# **Groundwater Application Review Summary Form**

Application # G- 18 621
GW Reviewer Across Bowchier Date Review Completed: 9/20/2018
Summary of GW Availability and Injury Review:
[ ] Groundwater for the proposed use is either over appropriated, will not likely be available in the amounts requested without injury to prior water rights, OR will not likely be available within the capacity of the groundwater resource per Section B of the attached review form.
Summary of Potential for Substantial Interference Review:
[ ] There is the potential for substantial interference per Section C of the attached review form.
Summary of Well Construction Assessment:
[ ] The well does not appear to meet current well construction standards per Section D of the attached review form. Route through Well Construction and Compliance Section.
This is only a summary. Documentation is attached and should be read thoroughly to understand the

# PUBLIC INTEREST REVIEW FOR GROUNDWATER APPLICATIONS

TO:	Γ.		r Rights Sec		•	Date 9/20/2018 Aurora Bouchier									
FROM	FROM: Groundwater Section  SUBJECT: Application G- 18621						ewer's Nam								
SUBJI	ECT:	Appl	ication G- <u>1</u>	8621		Su	persedes	rev	iew o

Results of Hunt-1999 Stream Depletion Model

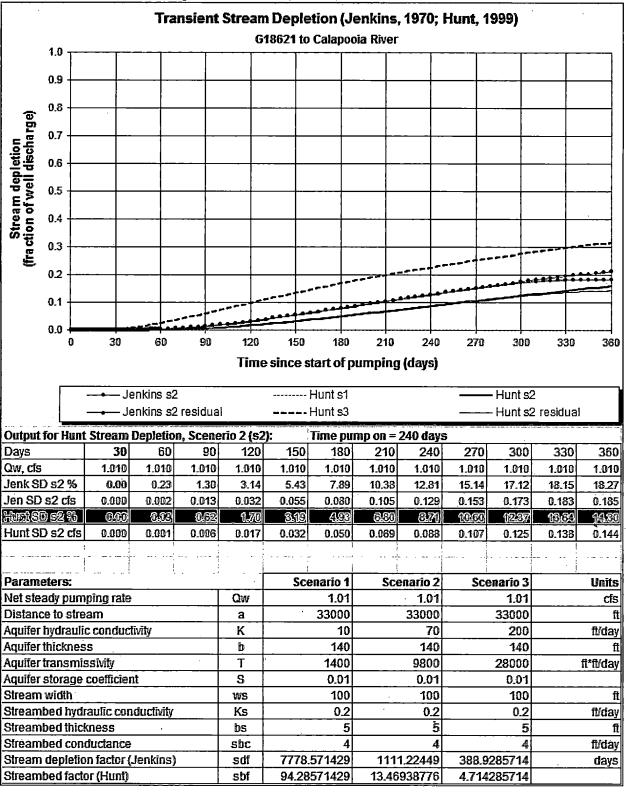
(B) = 80 %  Nat. Q		650	575	423	234	111	49	26	22.7	29.6	133	499
(C) = 1 %  Nat.  Q	5.92	6.50	5.75	4.23	2.34	1.11	0.49	0.2	6 0.23	0.30	1.33	4.99
(D) = (A) > (C)		T		^`` <u>`</u>	,	· · · ·	(e)			1		- 10 × 1
$(E) = (A / B) \times 100$	%	%	0 %	<<1%	<<1%	<<1%	<<1%	<<1	% <1%	<<1%	<<1%	<<1%
stream der	ght the chec mpact evaletion by p	ckmark for e aluation:	ach month Impacts to Iltimately	where (A) o the Cal , the high	) is greater i apooia Riv transmiss	than (C); (ver were existing to the interest of the interest o	E) = total i valuated u thickness	nterferonsing the of the	of calculated ence divided t ne Hunt (199 aquifer and	y 80% flov 99) analyti	v as percen cal model	tage. for

Results of Hunt-1999 Stream Depletion Model

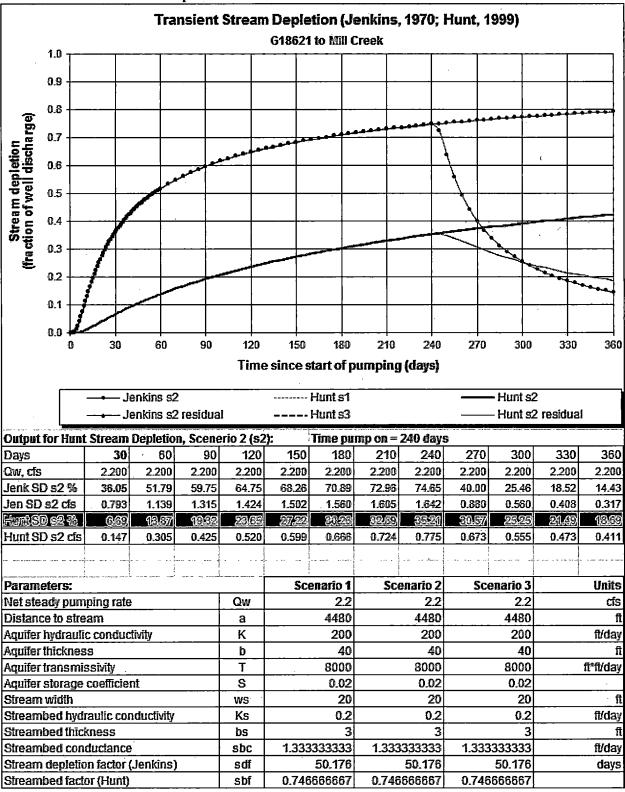
Comments: Impacts to Mill Creek were evaluated using the Hunt (1999) analytical model for stream depletion by pumping. Published aquifer parameters for the Upper Sedimentary Unit include hydraulic conductivity values (calculated from specific capacity and aquifer tests) which ranges from 0.03 to 7,000 feet per day (with an average of 200 ft/day) and specific yield values (also calculated from specific capacity and aquifer tests) which ranges from 0.003 - 0.2. Using the average hydraulic conductivity value of 200 ft/day and changing the specific yield the interference at 30-days ranges from 0.26% to 32%. A specific yield value of 0.02 ft/day results in interference at 30-days of 6.69%.

(A) = total interference as CFS; (B) = WAB calculated natural flow at 80% exceed. as CFS; (C) = 1% of calculated natural flow at 80% exceed. as CFS; (D) = highlight the checkmark for each month where (A) is greater than (C); (E) = total interference divided by 80% flow as percentage. Basis for impact evaluation: Impacts to the South Santiam River were evaluated using the Hunt (1999) analytical model for stream depletion by pumping. As stated in section Cb, published aquifer parameters for the Upper Sedimentary Unit include hydraulic conductivity values (calculated from specific capacity and aquifer tests) which ranges from 0.03 to 7,000 feet per day (with an average of 200 ft/day) and specific yield values (also calculated from specific capacity and aquifer tests) which ranges from 0.003 - 0.2. The mid-range specific yield value of 0.02 ft/day was used to model the interference to the South Santiam River.
